Executive Director's Recommendation

Commission Meeting: December 3, 2020

PROJECT Hirshhorn Museum Sculpture Garden Revitalization Hirshhorn Museum and Sculpture Garden Independence Avenue, SW & 7th Street, SW Washington, DC	NCPC FILE NUMBER 7889
SUBMITTED BY Smithsonian Institution	NCPC MAP FILE NUMBER 1.71(38.00)45227
REVIEW AUTHORITY Federal Projects in the District per 40 U.S.C. § 8722(b)(1) and (d)	APPLICANT'S REQUEST Approval of preliminary site development plans
	PROPOSED ACTION Approve preliminary site development plans with comments
	ACTION ITEM TYPE Staff Presentation

SITE PLAN - CENTRAL GALLERY

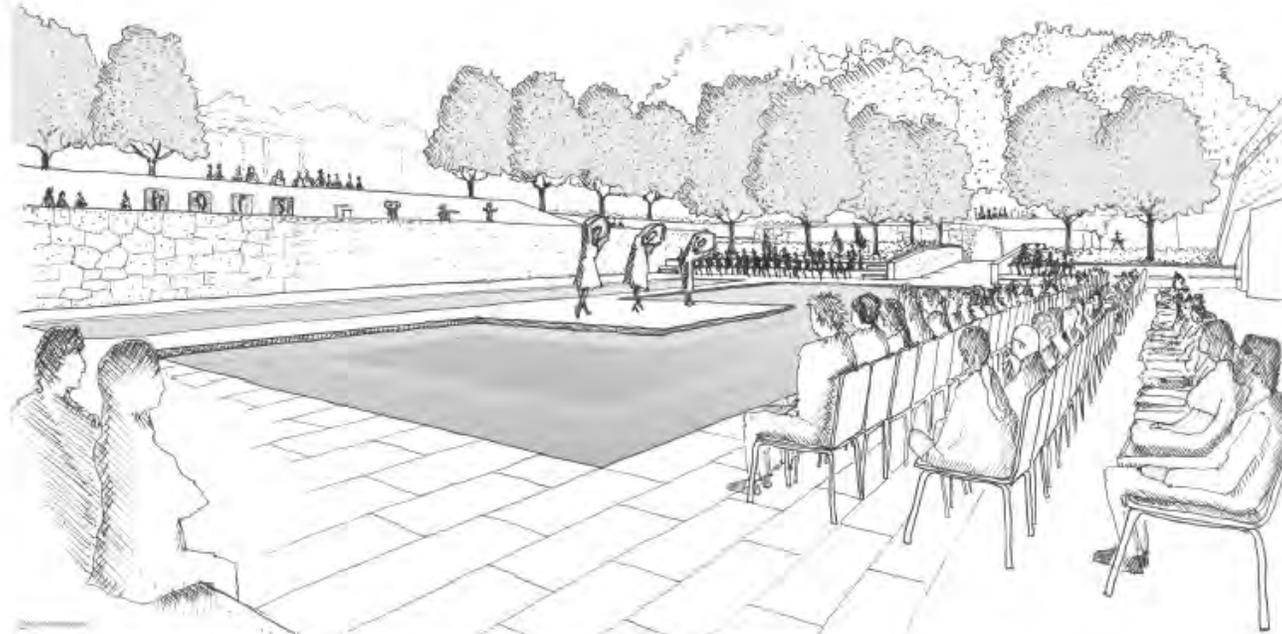
Recommends the applicant provide a comprehensive rationale for the programming needs that require the expanded aprons around the Bunshaft reflecting pool and study other design alternatives prior to any Commission consideration.

However, staff recommends the **Commission find the design for the proposed treatment of the Bunshaft reflecting pool, with the expanded apron of water on three sides, does not visually retain the distinct dimensions of the original reflecting pool and that the program need for the expansion is unclear.** As such, staff suggest the **Commission recommends the applicant provide a comprehensive rationale for the programming needs that require the expanded aprons around the Bunshaft reflecting pool and study other design alternatives prior to any Commission consideration.**

CONCRETE WALLS

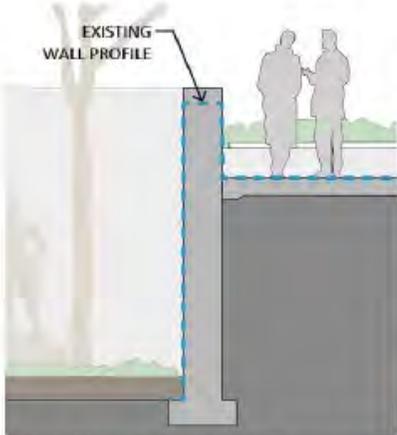
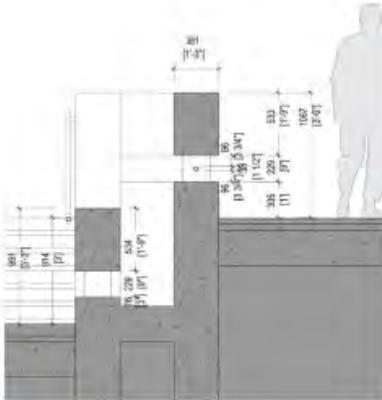
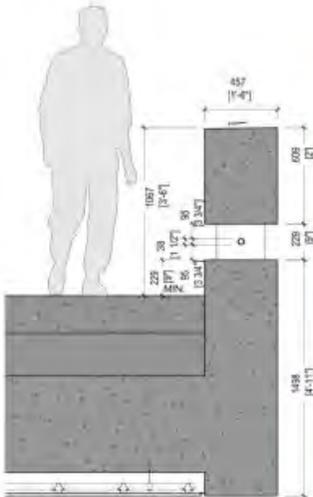
Supports the effort to replace the failing original perimeter aggregate walls of Bunshaft's design with in-kind materials, consisting of Swenson Pink aggregate, to maintain these character-defining elements.

Under the plan, the original perimeter concrete aggregate walls that were part of Bunshaft's design will be replaced with in-kind material. According to SI, the replacement is needed due to the structural failing of the original walls. These walls will be re-built in the original locations, with the in-kind material consisting of sandblasted exposed crushed granite aggregate. The walls will also be slightly raised to meet current building codes. Thus, staff notes that all the existing concrete walls within the Sculpture Garden suffer from alkali silica reactions (concrete disease) and require replacement. The existing perimeter walls are contributing elements to Bunshaft's garden design and the concrete aggregate material directly relates the sculpture garden to the museum building. In addition, staff recommends the **Commission support the effort to replace the failing original perimeter aggregate walls of Bunshaft's design with in-kind materials, consisting of Swenson Pink aggregate, to maintain these character-defining elements.**

Inner Partition Wall

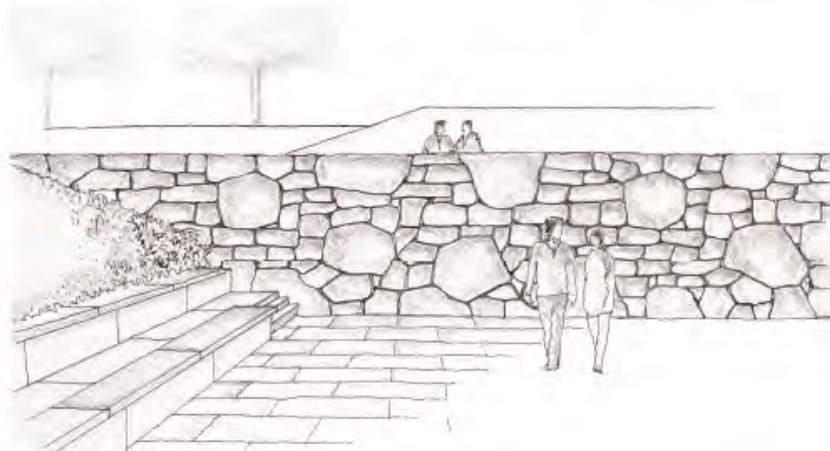
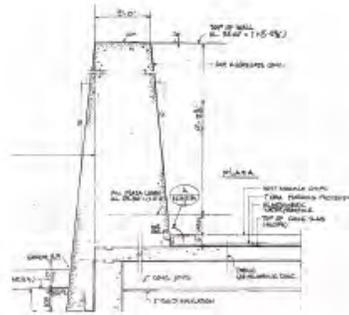
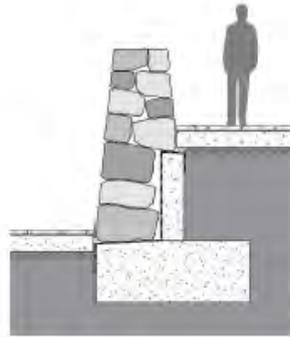
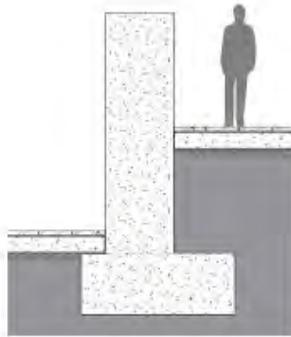
Notes the applicant proposes to change the inner partition wall's material composition from the original concrete aggregate to stacked stone, with some Swenson Pink granite stones incorporated, noting the change is part of an artistic vision for the overall garden.

Recommends the applicant provide a comprehensive rationale of the programming need for the change in material prior to any Commission consideration.

Consistent with the original garden design, staff recommends the **Commission finds the inner partition wall is a central focus of the overall garden and backdrop to the reflecting pool and the concrete aggregate material directly relates the sculpture garden to the museum building.** The **Commission finds that the applicant has not demonstrated a strong programmatic rationale for altering this character defining feature.** Therefore, the **Commission recommends the applicant provide a comprehensive rationale of the programming need for the change in material prior to any Commission consideration.**

REFLECTING POOL

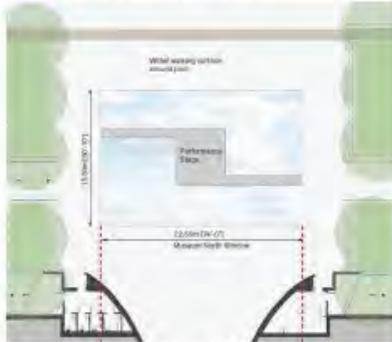
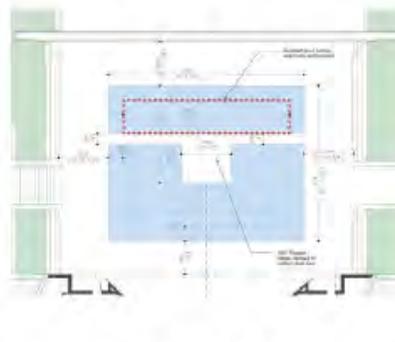
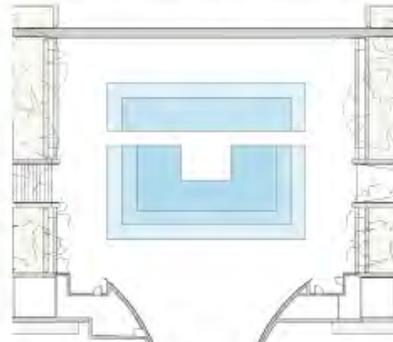
The concept plan in 2019 included several alternatives for a re-design of the reflecting pool, all of which significantly enlarged the historic pool. The Commission's comments in 2019 included the following request and recommendation:

- *Requests* the applicant provide additional details regarding the proposed pool modifications, including the design of the proposed stage and pedestrian paths, to demonstrate the impacts of any changes on the historic character of the pool and the visitor experience.
- *Recommends* the applicant explore a pool alternative that retains the historic character-defining dimensions of Bunshaft's pool design.
